Jackson Rancheria RV Park
Registration Building Remodel
Jackson, CA.

Title:
MECHANICAL REFLECTED CEILING PLAN NEW

M-3.0

Bid Set
08/27/2023

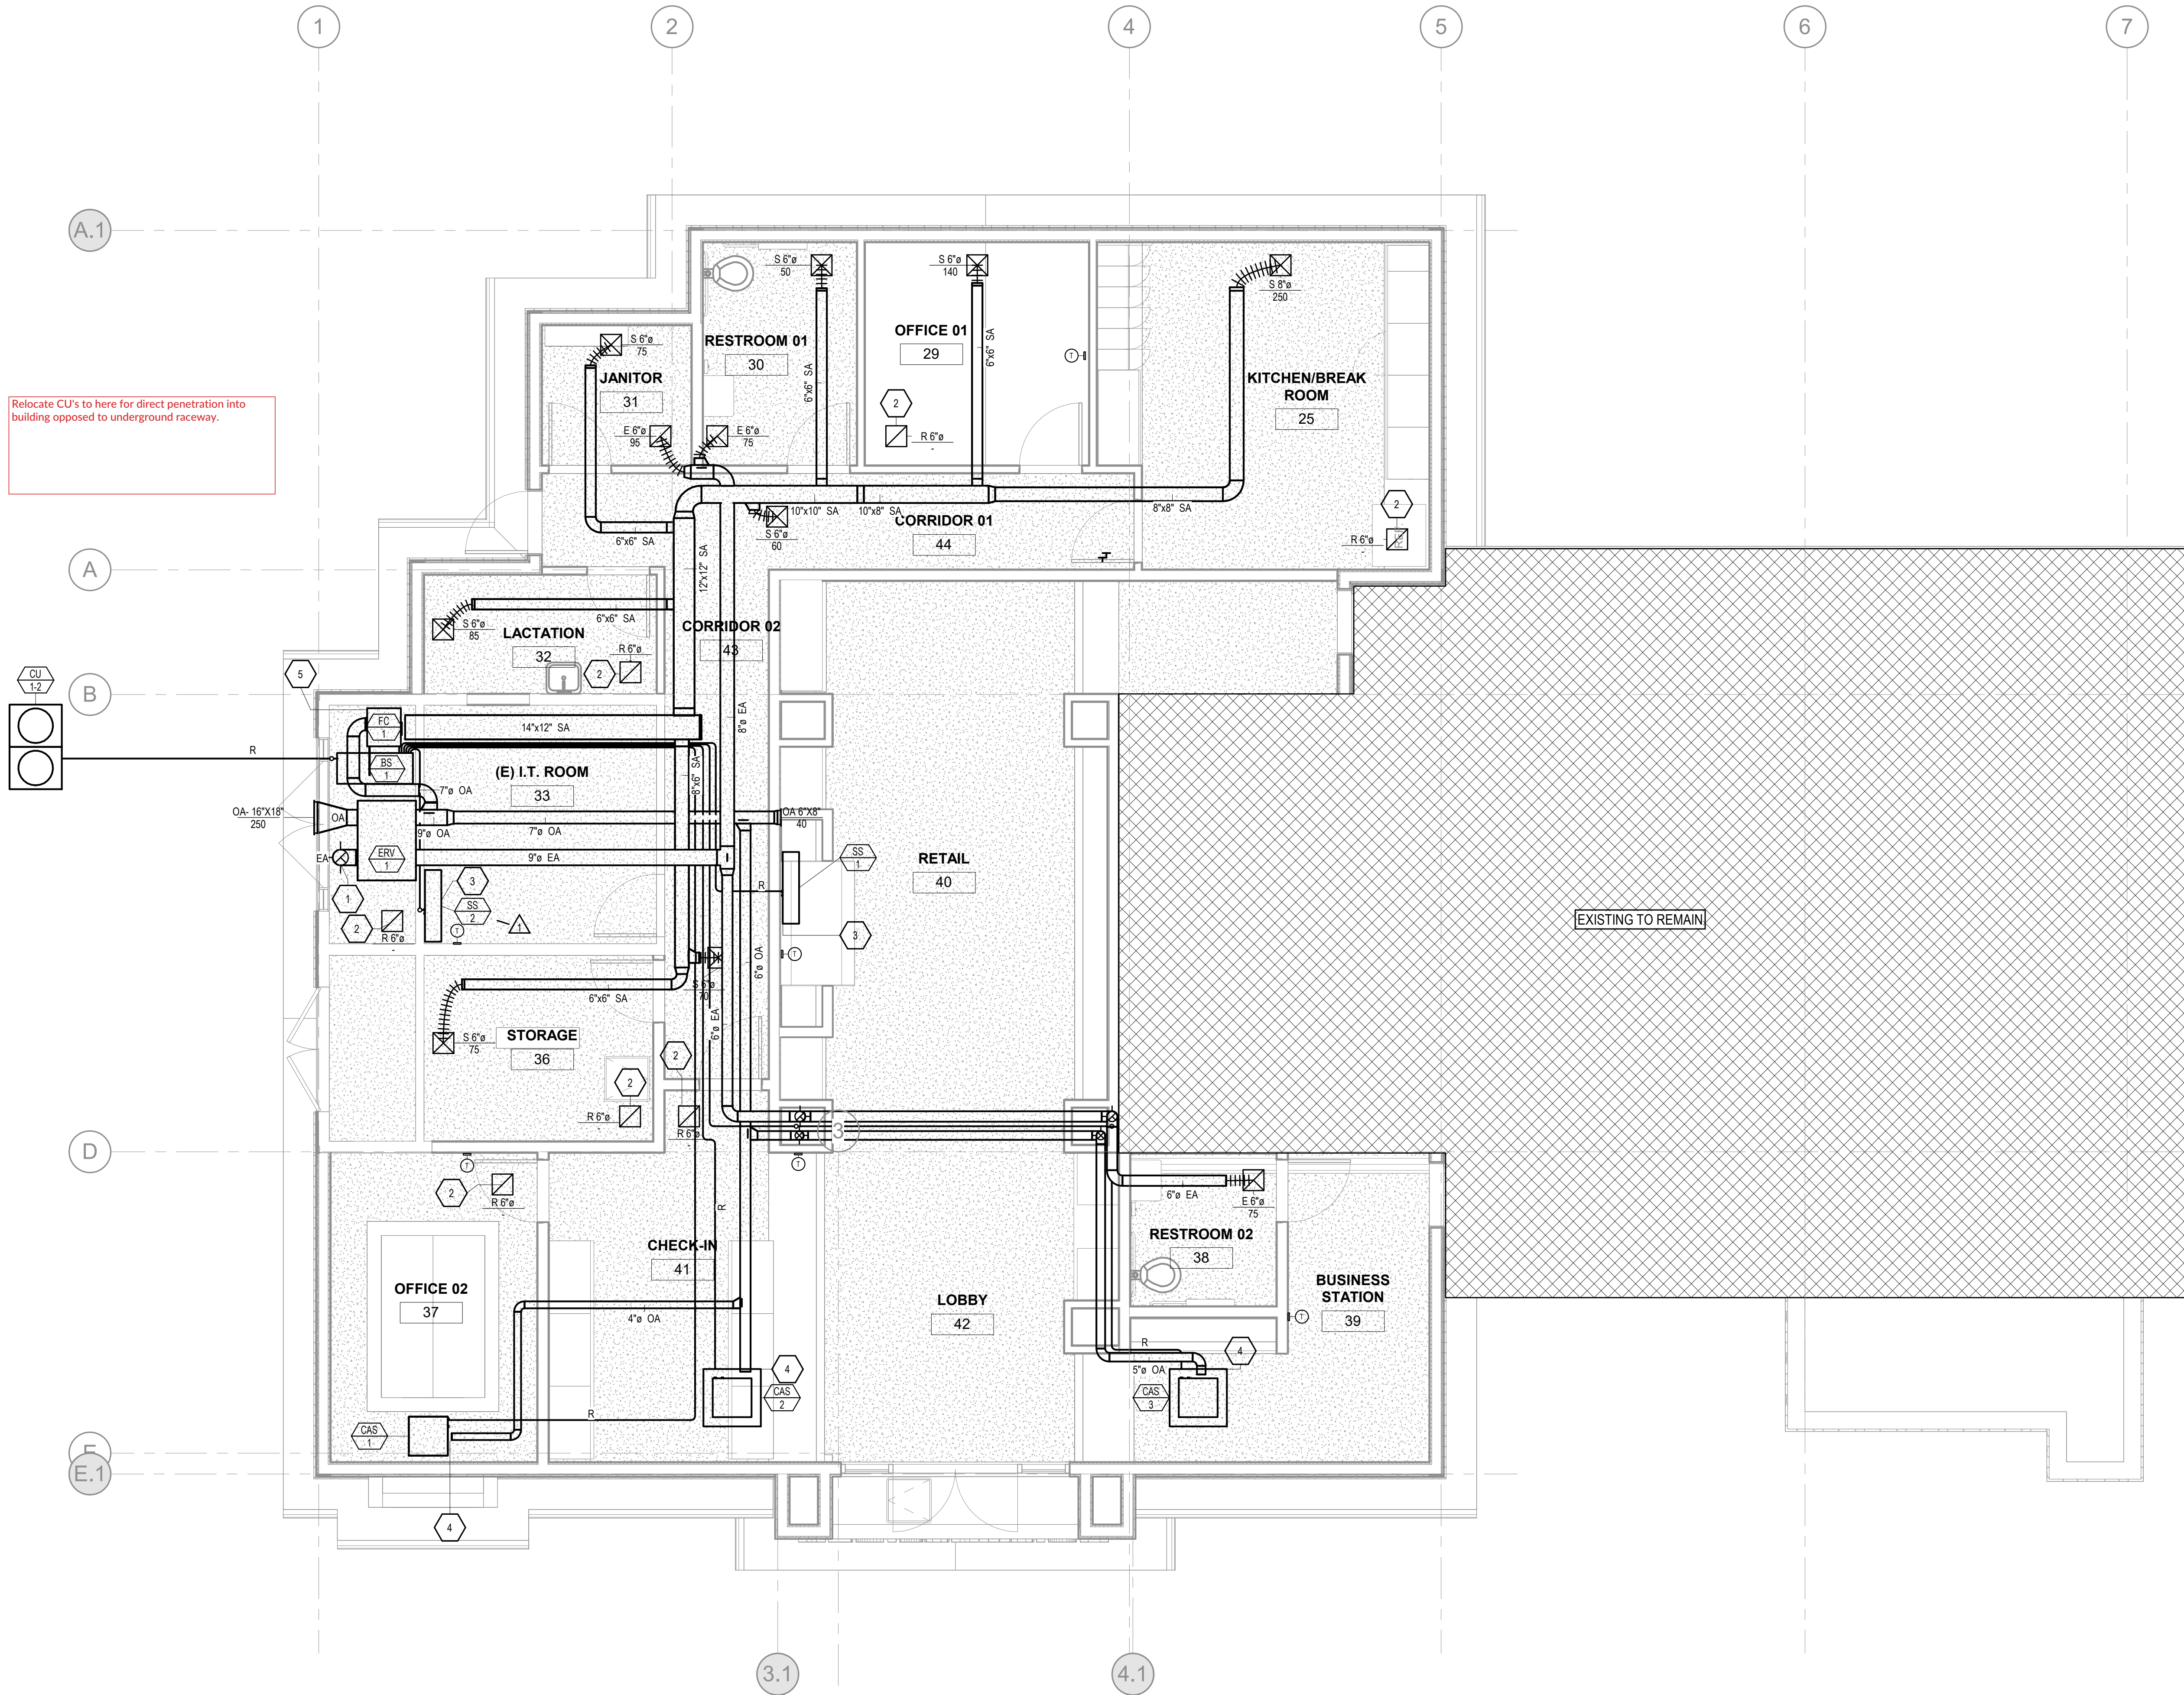
Relocate CU's to here for direct penetration into building opposed to underground raceway.
